**DEPARTMENT OF THE ARMY
WILMINGTON DISTRICT, CORPS OF ENGINEERS**

Action ID No. 1993-02466

Reference the Department of the Army (DA) individual permit (IP) Action SAW-1993-02466, issued April 18, 2019 to construct a new US 70 bypass of Havelock, North Carolina in Craven County, North Carolina.

Subject: Modification of 401 Water Quality Certification Pursuant to Section 401 of the Federal Clean Water Act and Neuse Buffer Authorization with ADDITIONAL CONDITIONS for the proposed construction of the Havelock Bypass in Craven County, TIP R-1015.
NCDWR Project No. 20181598 v.2

PERMIT DRAWING
SHEET 149 OF 167

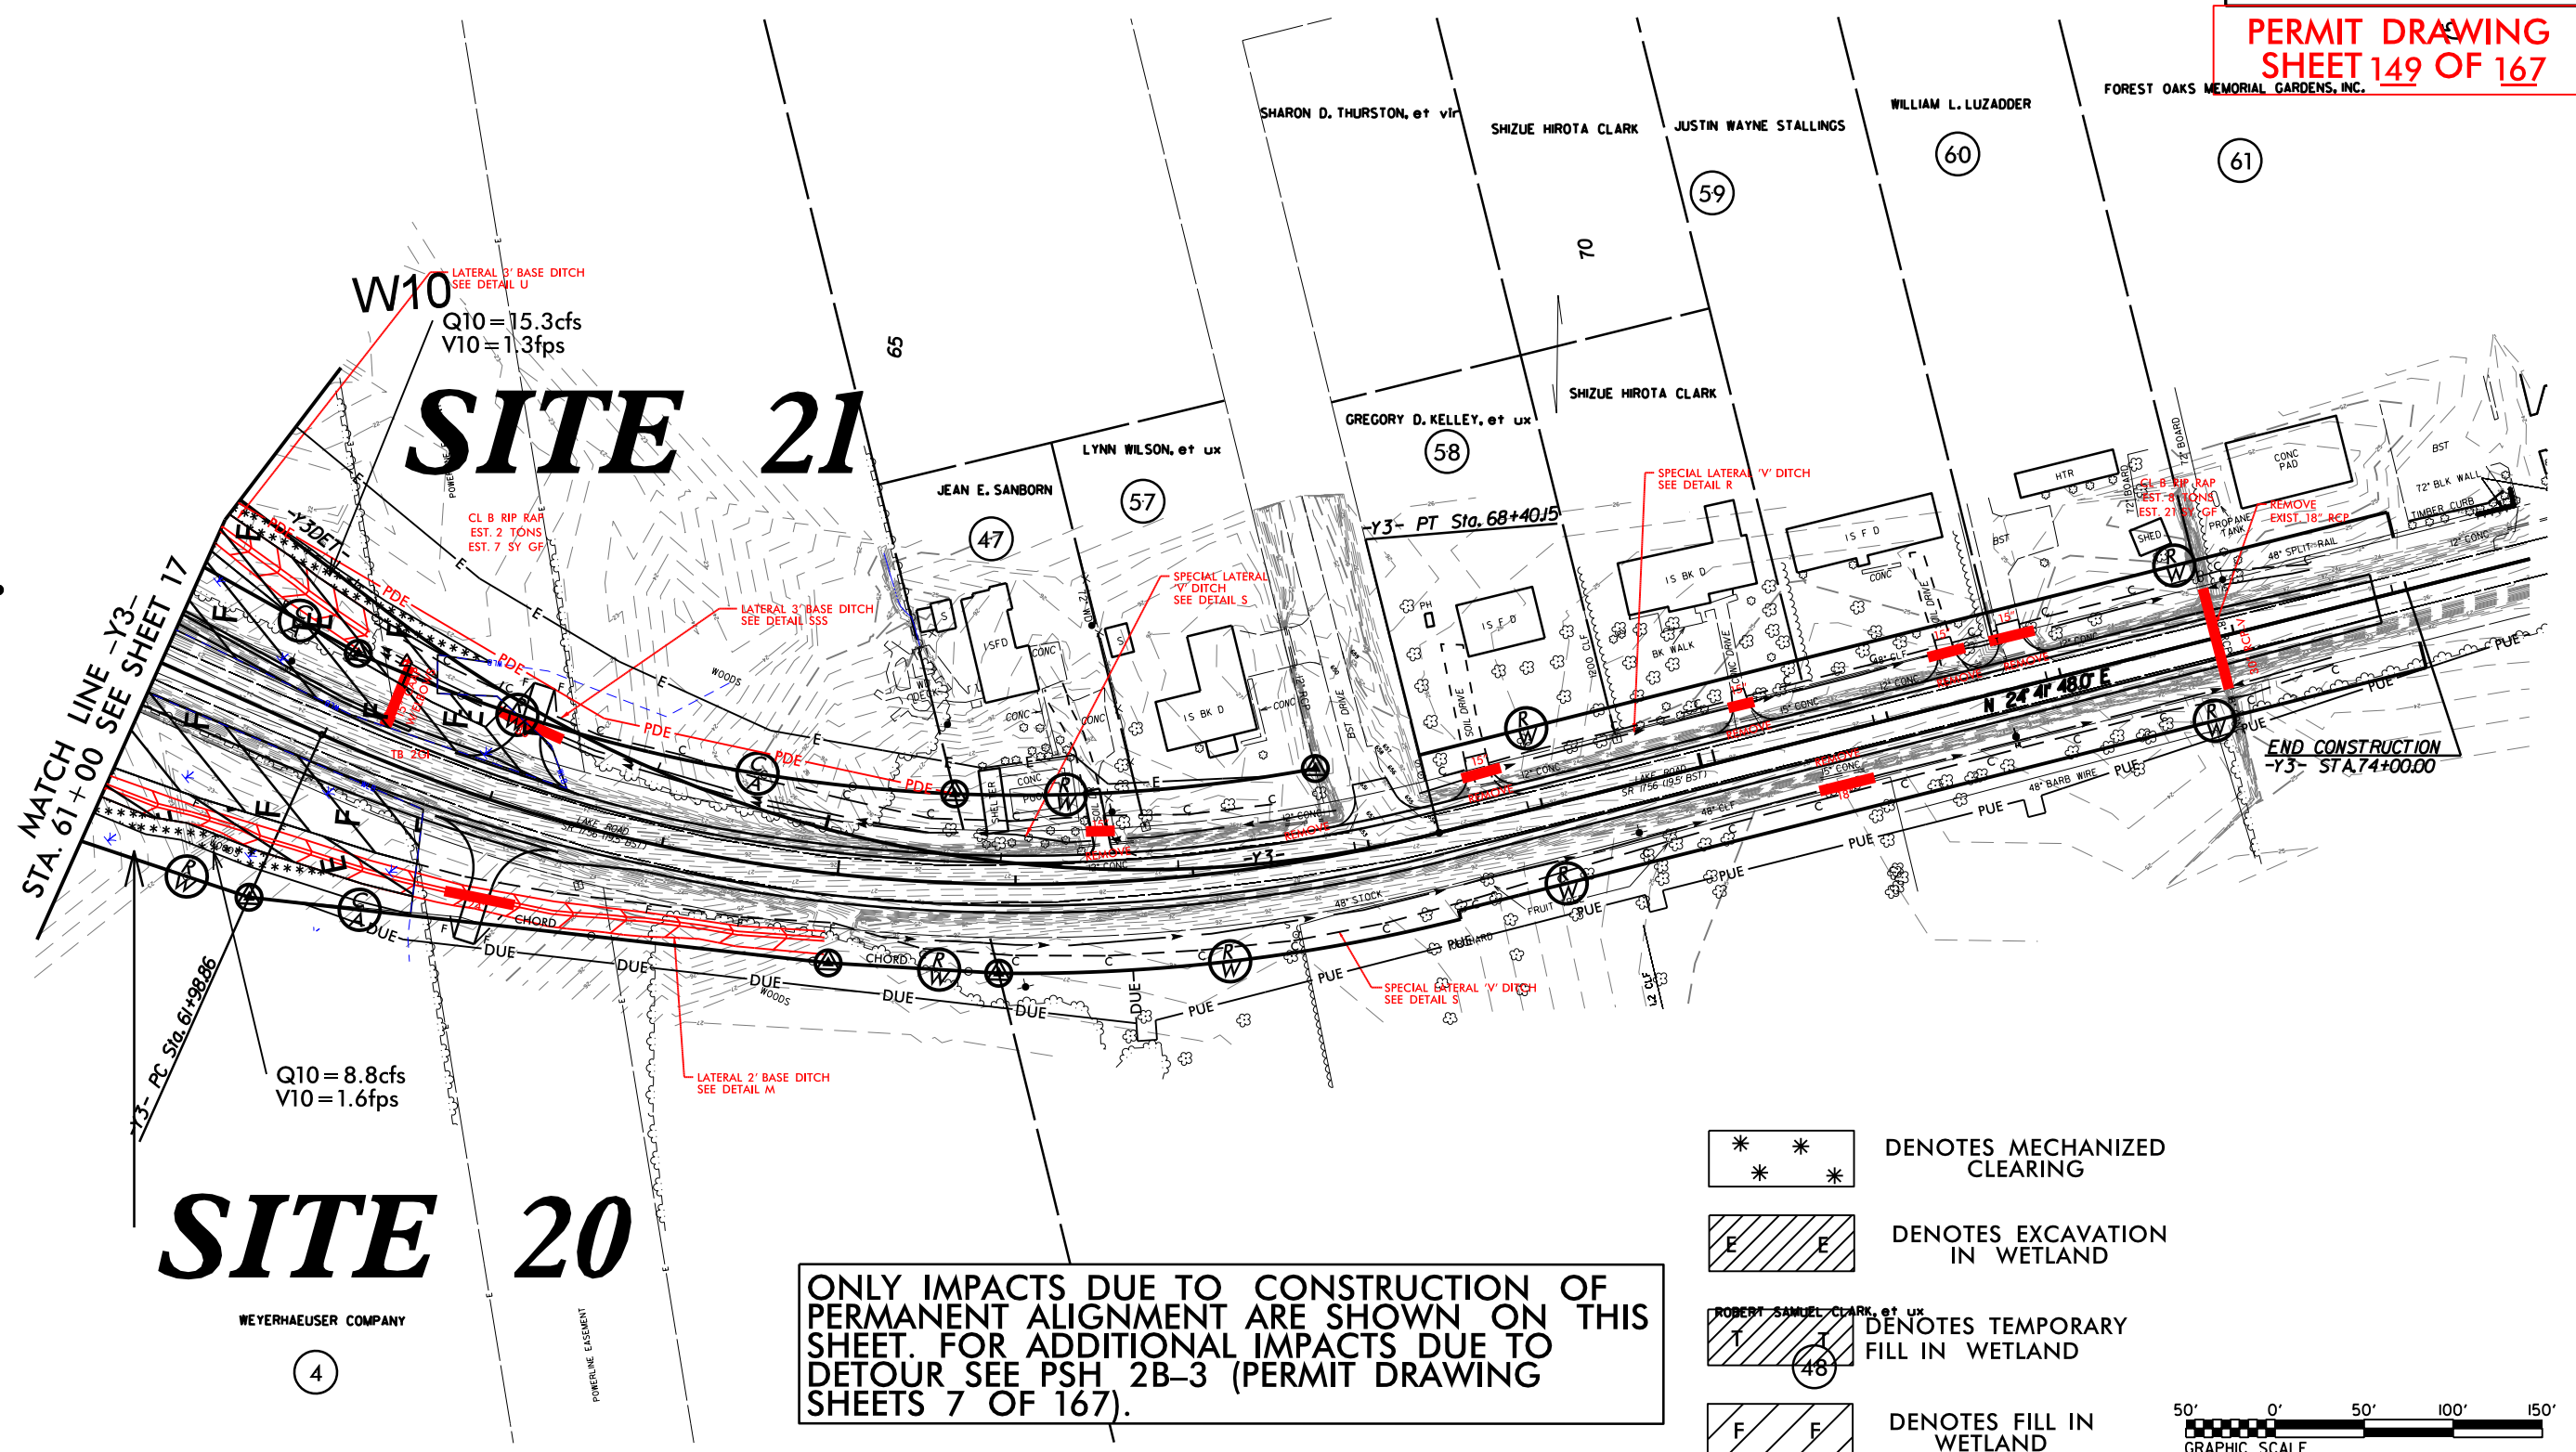
- Site 21 (permit sheets 148 &149) pipe outlet shifted. Fill increased, excavation decreased, no change to total impacts permitted for site (0.85 acre).

PROJECT REFERENCE NO. R-1015		SHEET NO. NE-03	
ROADWAY DESIGN ENGINEER		HYDRAULICS ENGINEER	
DOCUMENT NOT CONSIDERED FINAL UNLESS ALL SIGNATURES COMPLETED			
moffatt & nichol		4700 FALLS OF NEUSE ROAD, SUITE 300 RALEIGH, NORTH CAROLINA 27602 919 881-4425 VOIC 919 881-4425 FAX NC License No. F-0105

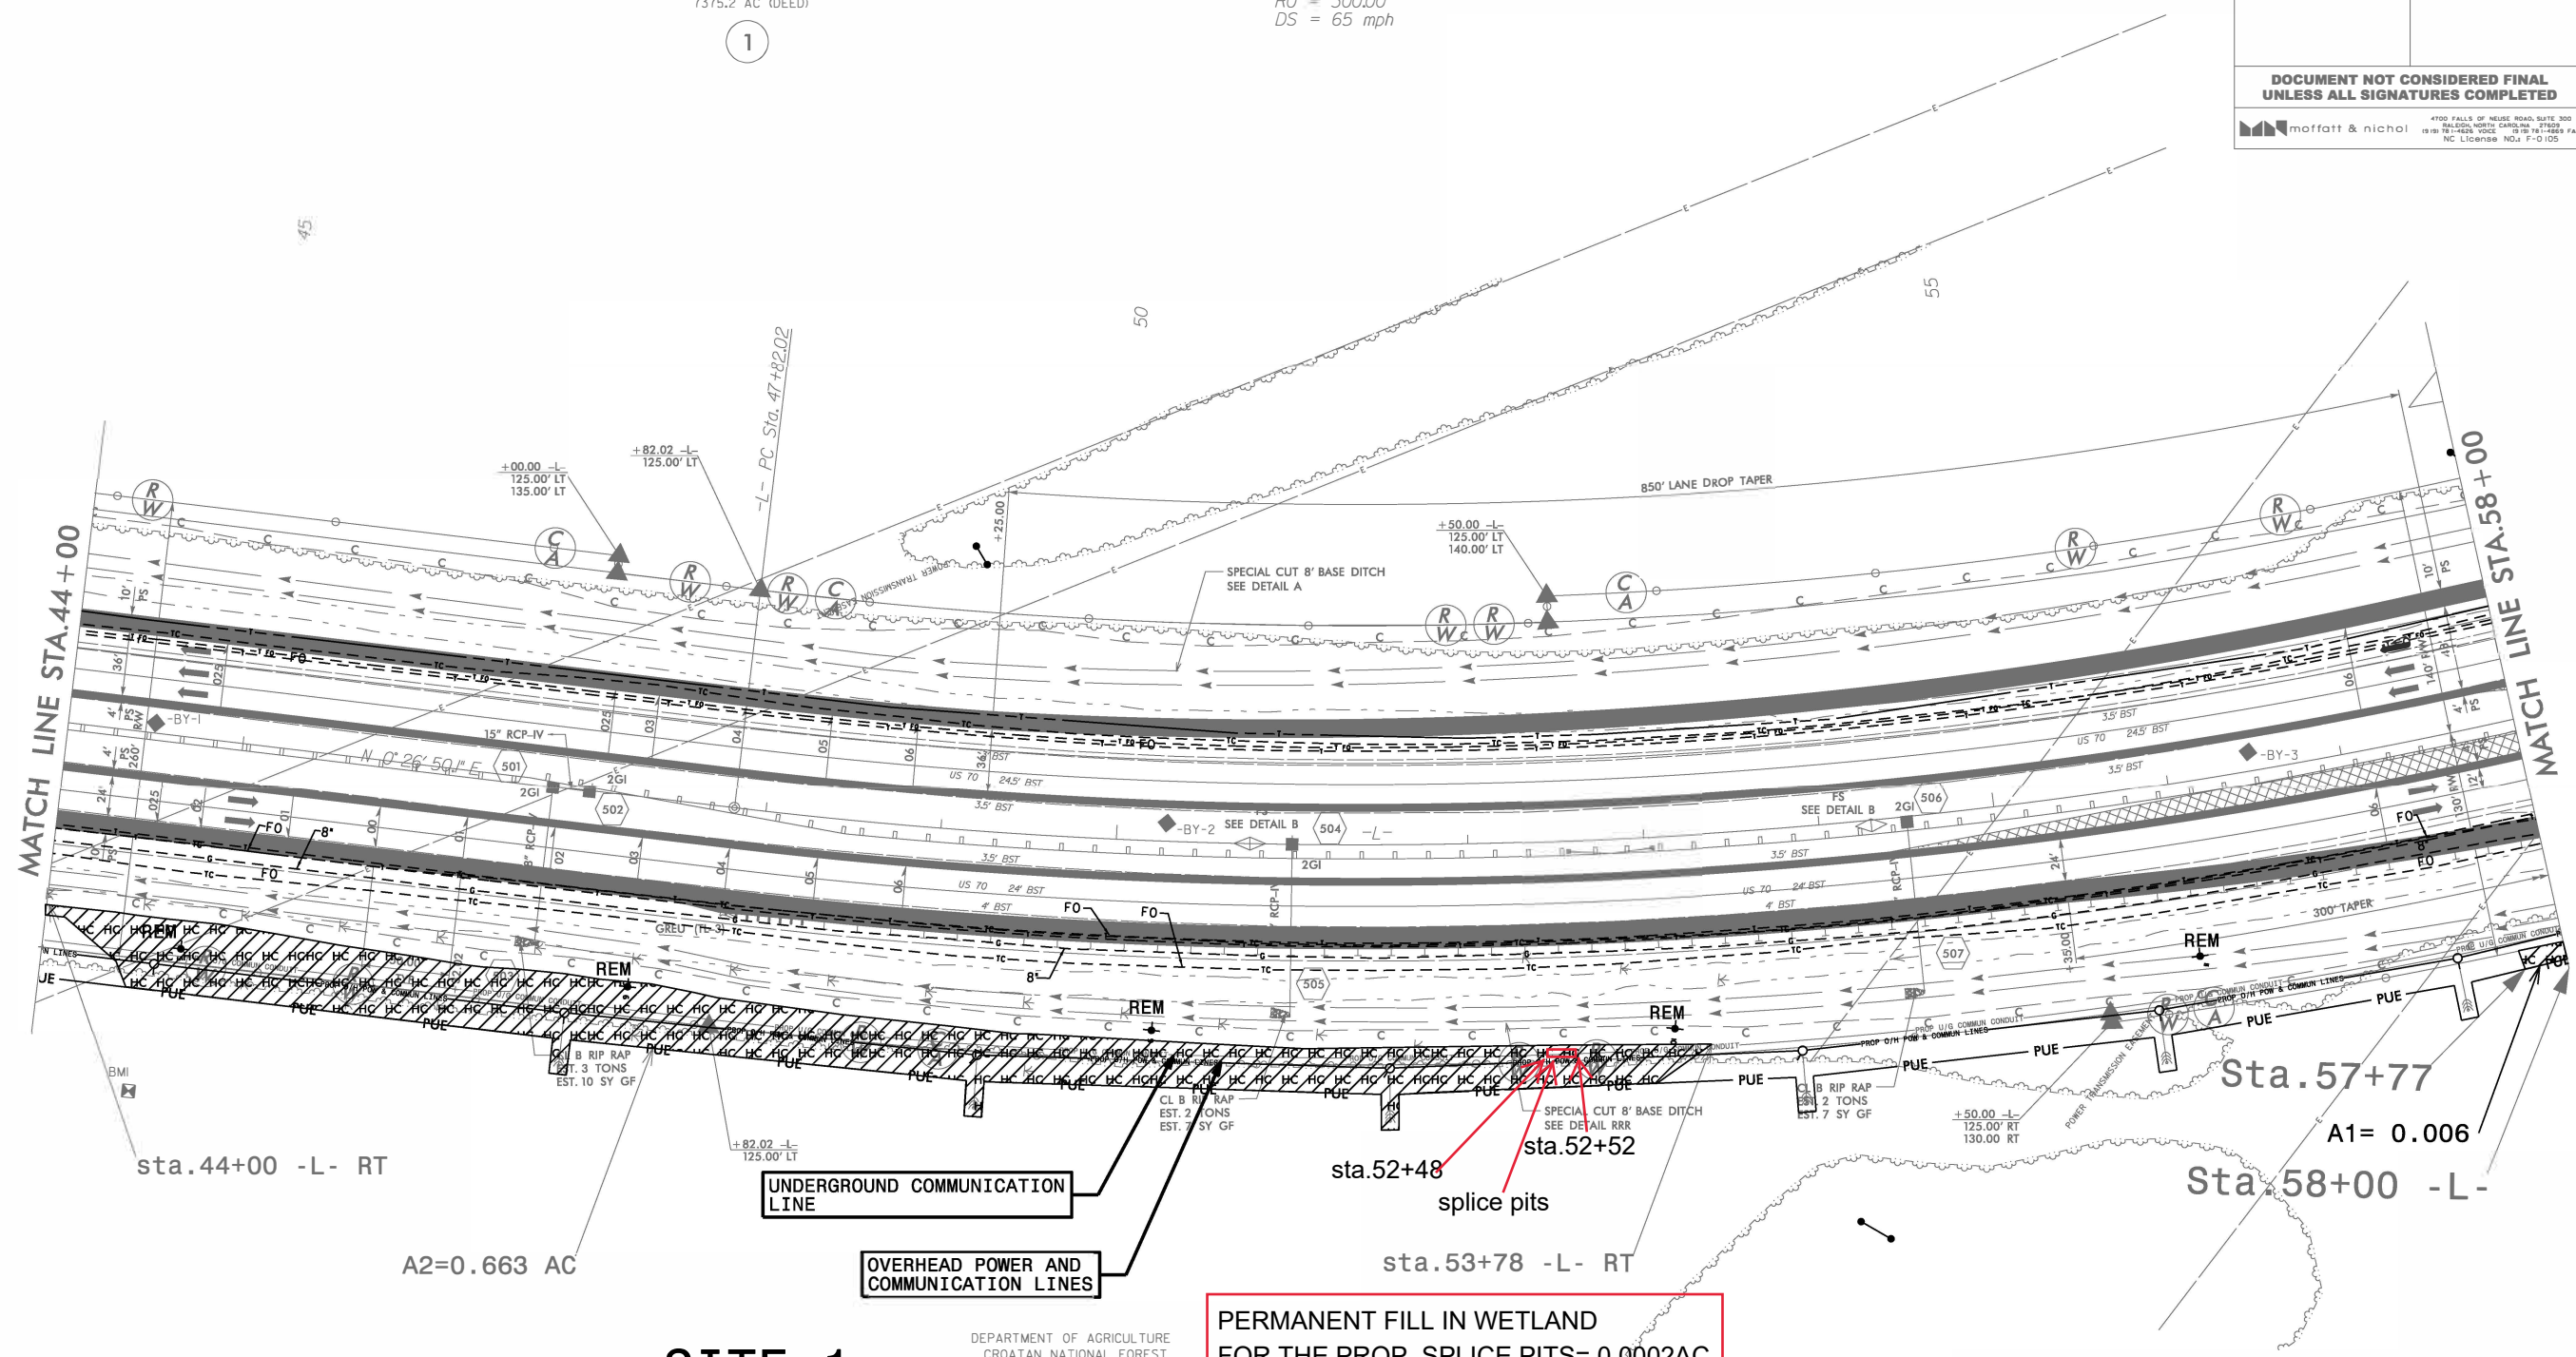
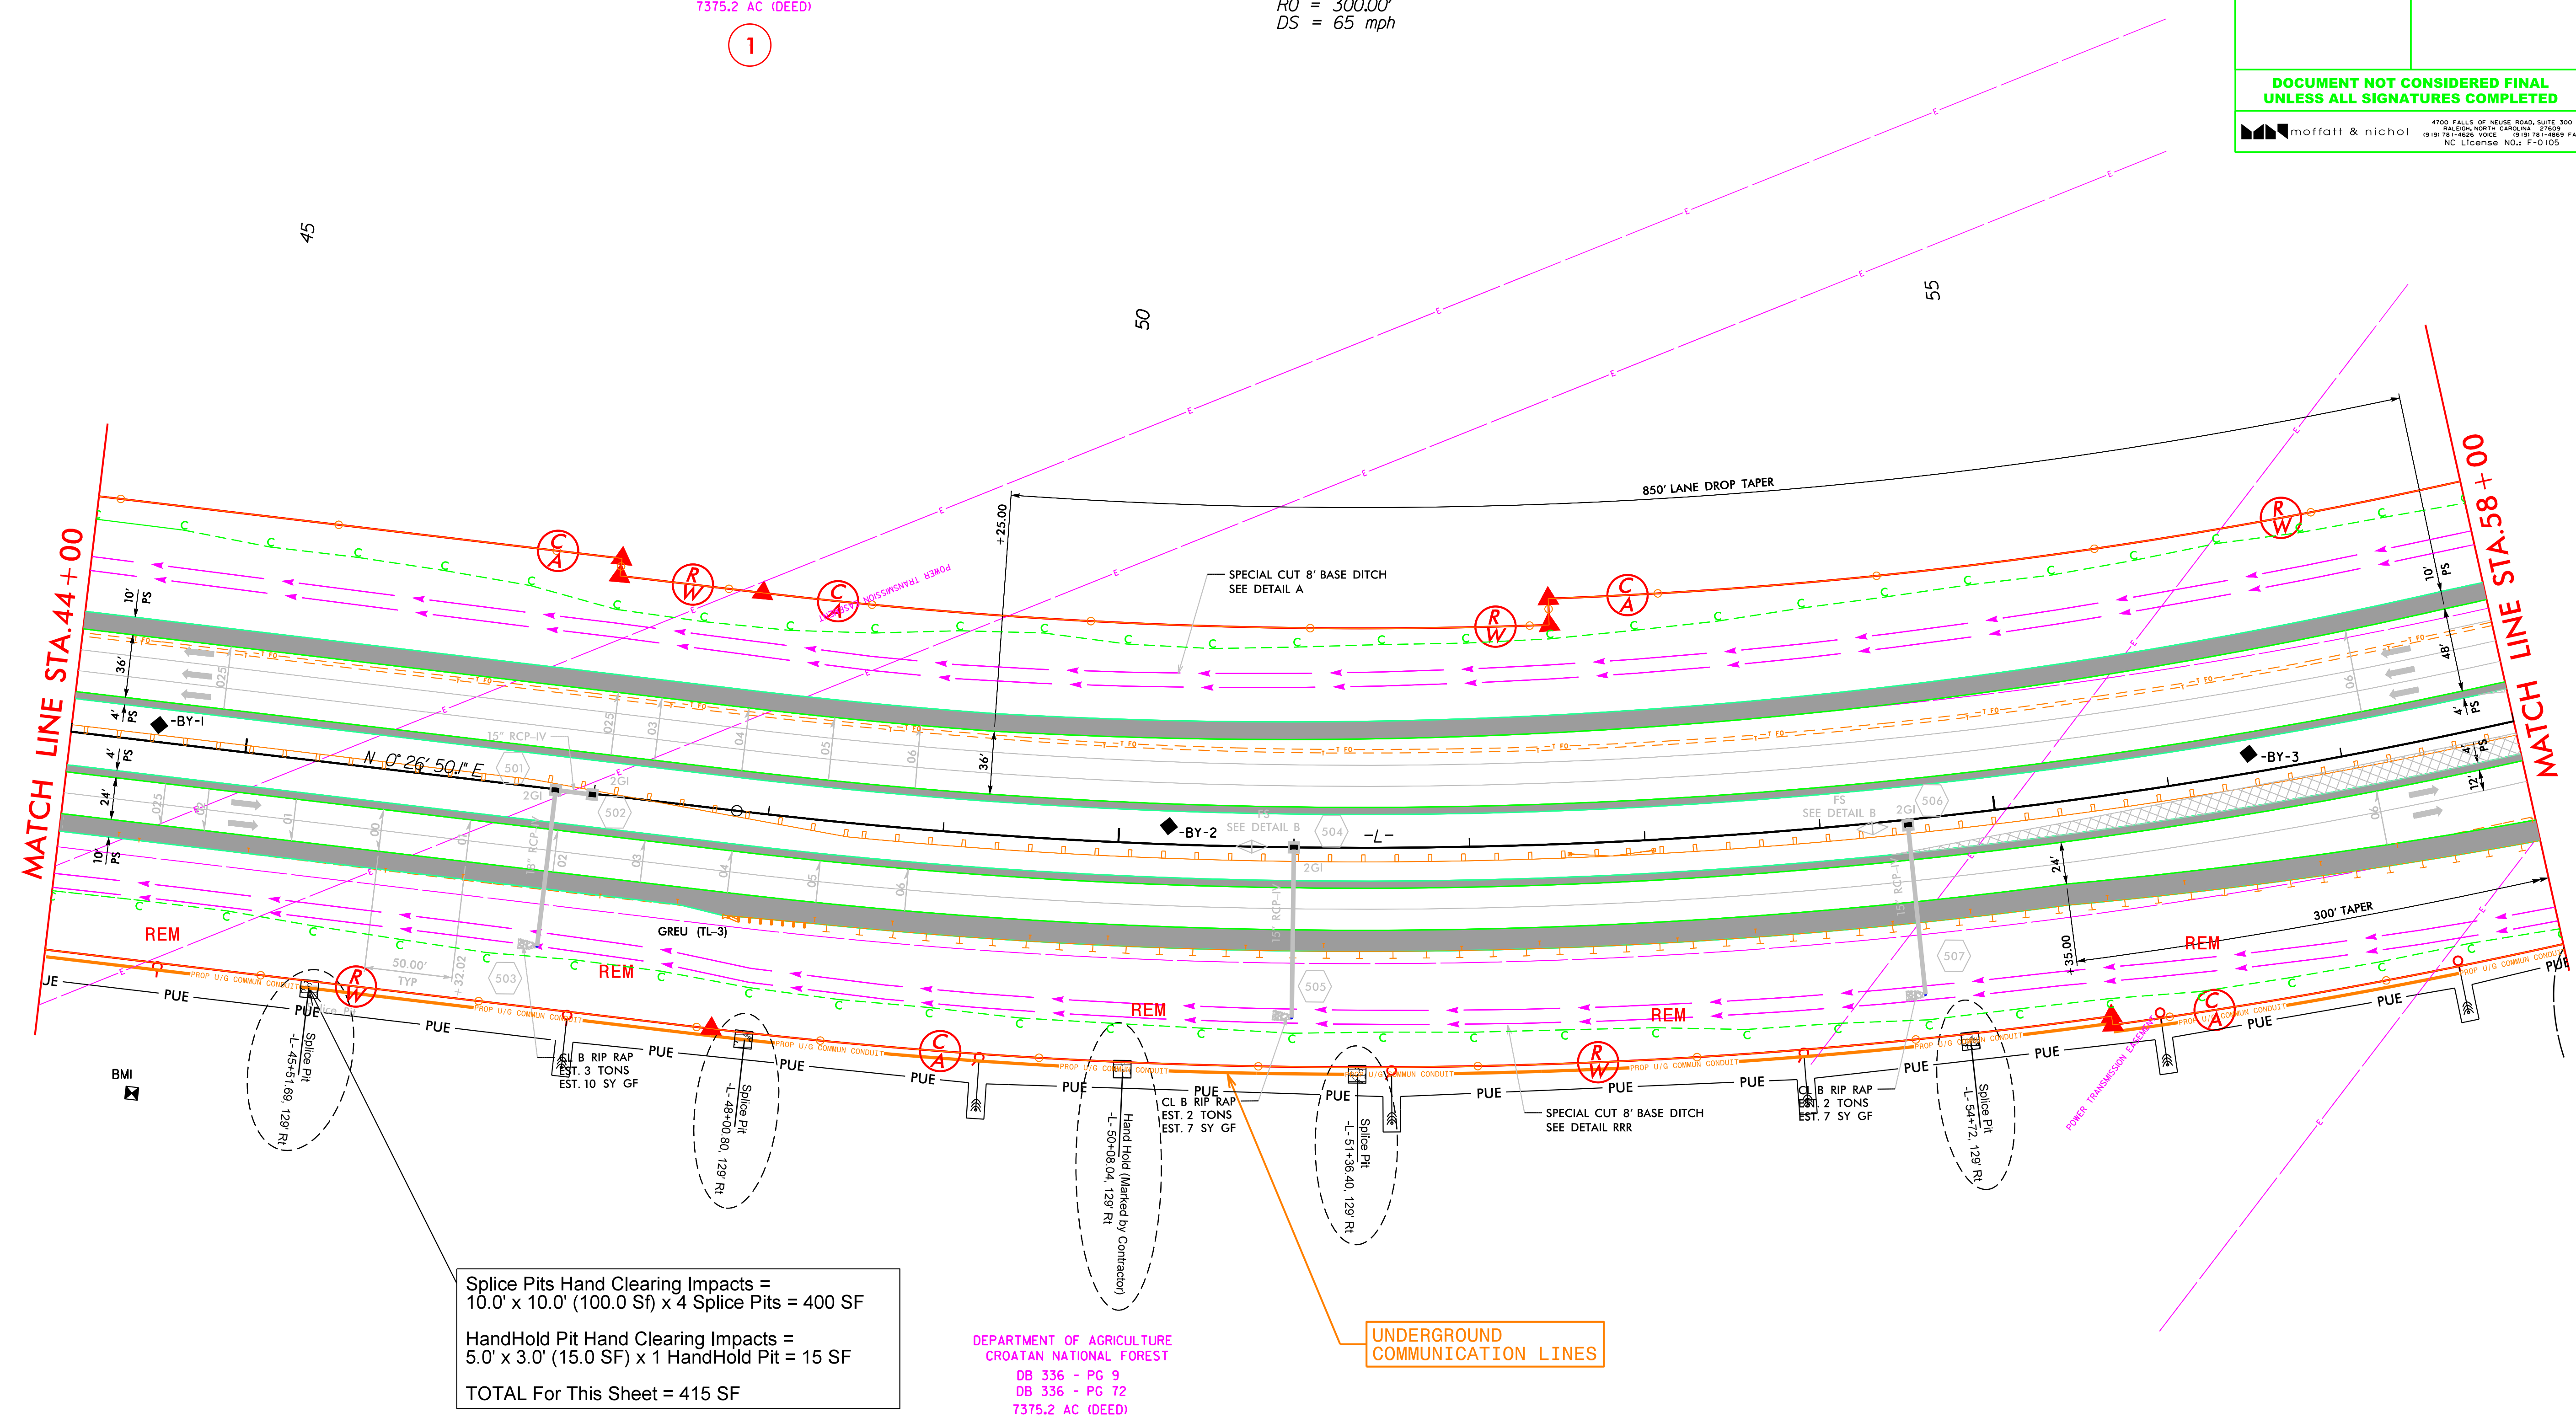
- Additional sheets have been prepared for the underground utility which requires additional impacts in wetland Sites 1, 2 and 3. The permit drawings showed underground utilities through these sections, but with no splice pits or hand holes, which are required. These supplemental drawings were revised by Division 2 to show the permanent hand holes and temporary splice pits with the total impacts required. These totals are not included in the summary sheet prepared by Hydraulics Unit. Impacts shown on the supplemental permit drawings are as follows:

- = NE-03, 400 s.f. for splice pits and 15 s.f. for hand holes
 - = NE-04, 500 s.f. for splice pits and 30 s.f. for hand holes
 - = NE-05, 600 s.f. for splice pits and 30 s.f. for hand holes
